DELEGATED AUTHORITY REPORT FOR COMBINED CODE ASSESSMENT DEVELOPMENT APPLICATION FOR MATERIAL CHANGE OF USE FOR WAREHOUSE AND OPERATIONAL WORKS FOR CHANGE TO GROUND LEVEL AT 2 COASTLINK COURT, STAPYLTON
COM/2026/226 **DIVISION NO. 3**

The purpose of this report is to assess an application for a development permit for a material change of use to establish Warehouse (dual tenancy with ancillary offices) and operational works for a change to ground level at 2 Coastlink Court, Stapylton.

***Figure 1**: Proposed site plan (Source: Applicant's common material)*

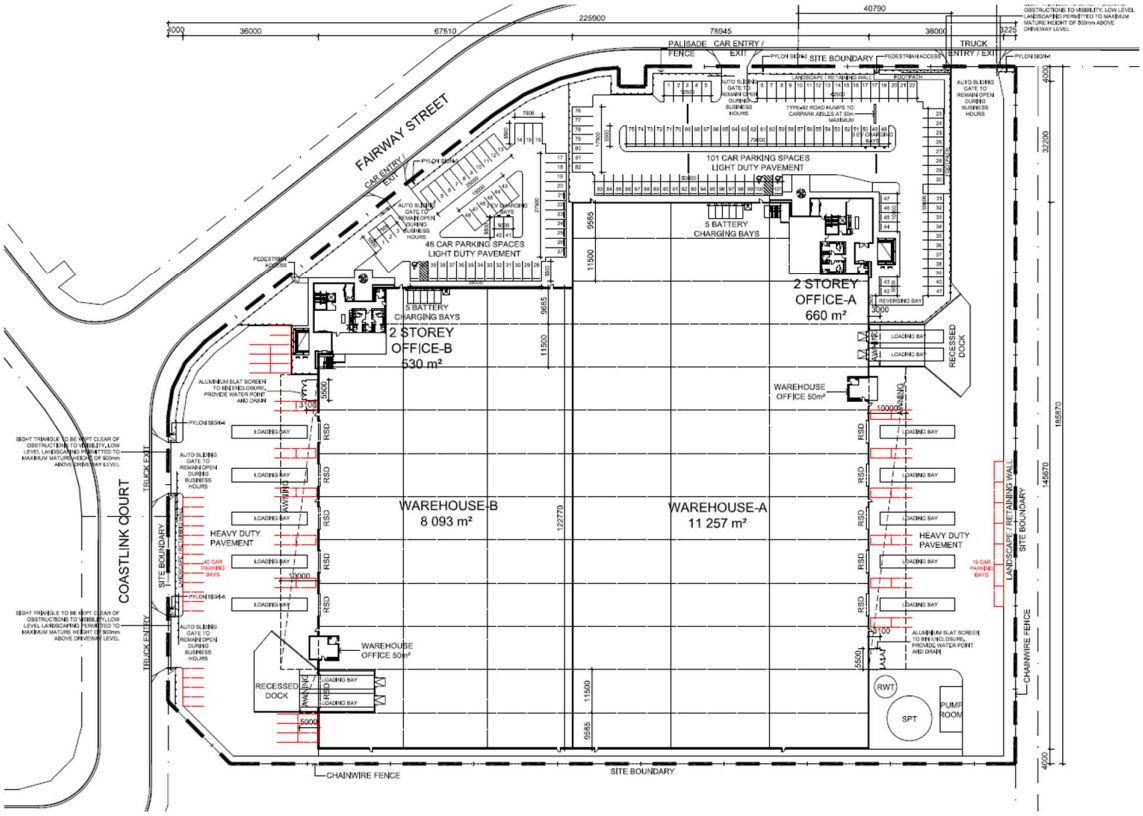
The original architectural plans indicated the proposed 1.8m high black palisade fence set back approximately 1.5m from the front property boundary and located within the landscaped area, while the Statement of Landscape Intent predominantly showed the fence on the boundary. This created an inconsistency and potential conflict with the required landscaped area.

The truck entry/exit vehicle crossing for Warehouse A on Fairway Street is located directly fronting a T-intersection. This location is within a prohibited area under AS2890.1 for commercial/industrial vehicle crossings. In response to the Information request the applicant provided an Amended Traffic Impact Assessment (signed by an RPEQ) demonstrating that the proposed crossover is appropriately aligned with the opposing road leg and effectively operates as a fourth leg of the existing intersection. The assessment concludes that the arrangement provides satisfactory visibility, geometry and manoeuvrability for heavy vehicles and is a safe and practical access solution. Officers accept this assessment.

In response to the Information Request the fence has been set back 2.5m from the property boundary. Officers have recommended a condition requiring the frontage fence to be located a minimum of 2.5m from the street boundary and to utilise discrete post footings (not strip footings) so that the full garden area on both sides of the fence remains available for tree root systems. Additional conditions require canopy trees at 6m centres along the frontage boundaries (located forward of the fence), supported by screening shrubs and groundcovers, together with street trees in the road reserve.

Based on the above assessment it is considered the development complies with PC55 of the M38 Industrial Estate Place Code.

***Figure 12**: Parking concept plan (Source: Applicant's common material)*

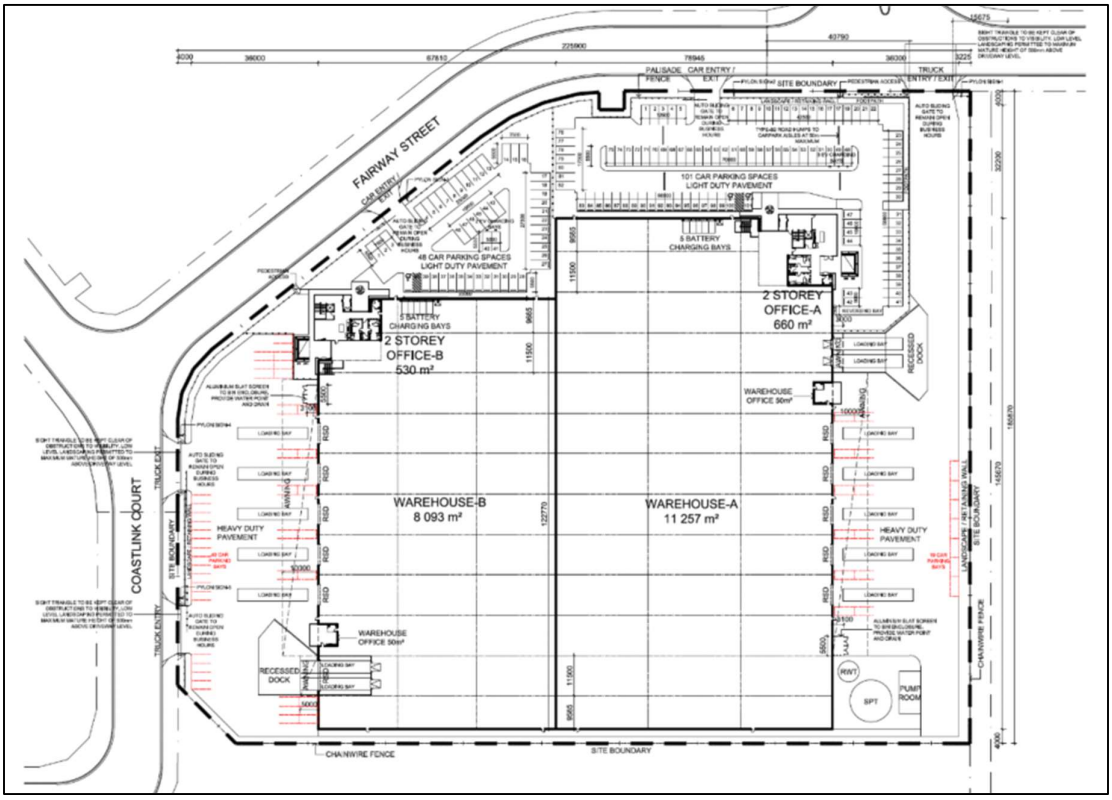
In support of compliance with Performance Criterion PC8, the applicant (via Rytenskild Traffic Engineering) has demonstrated that the reduced parking provision is appropriate having regard to the nature of pure warehouse development and observed parking utilisation at comparable warehouse sites within the surrounding industrial area. Officers note that Warehouse An indicative concept plan was also submitted showing that an additional 59 spaces could potentially be accommodated on hardstand areas in the future if required.

Officers note that even with these additional spaces a residual shortfall would remain, and the concept plan has not been endorsed as an approved drawing. However, Officers are satisfied that the site has capacity to accommodate additional parking in the future through modifications to the internal layout if needed. This approach is consistent with recent approvals within the Vantage Estate.

Based on the above assessment it is considered the development complies with PC8 of the M38 Industrial Estate Place Code.
